Environmental Defense Institute
Troy, Idaho 83871-0220
<http://www.environmental-defense-institute.org>

Keep Yellowstone Nuclear Free
Jackson, Wyoming 83001-4757
<http://www.yellowstonenuclearfree.com>

February 28, 2007

RE: Preliminary Comments on U.S. Department of Energy Class 3 Modified Permit to the Volume 14 for the Idaho Nuclear Technology and Engineering Center (INTEC) at the Idaho National Laboratory, Permit Number EPA ID No. ID4890008952I INTEC Liquid Waste Management System and the Integrated Waste Treatment Unit. IDEQ Public Notice of Intent 1/26/07 to approve Class 3 Permit Modifications of Volume 14, Docket Number 10HW-0701.

FIGURE 2-4.
Current INTEC high-level waste system
simplified flow diagram.

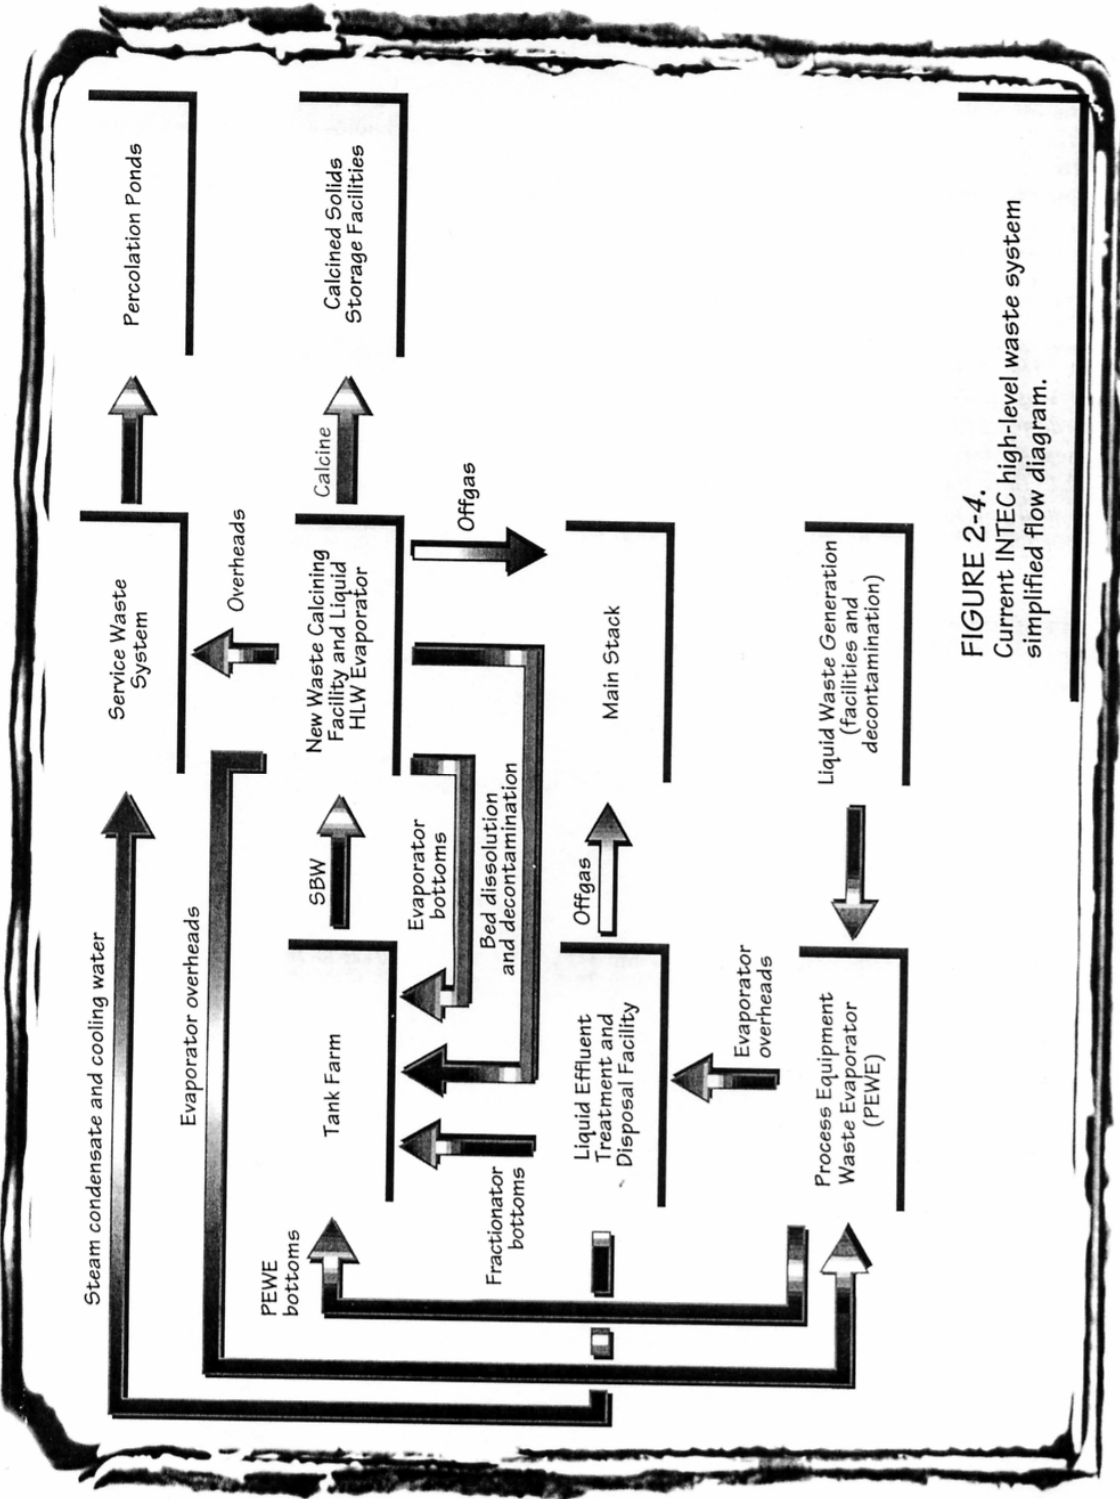
The DOE HLW &FD EIS (DOE/EIS-0287D) page 1-13 (Figure 1-6) and DOE/EIS-0287 Final page 2-11 (figure 2-4) clearly shows the High-level Liquid Waste Evaporator also housed in the New Waste Calciner building, and now called the ETS, emissions go directly to the INTEC main stack. ⁷¹ See Attachment C Schematic.
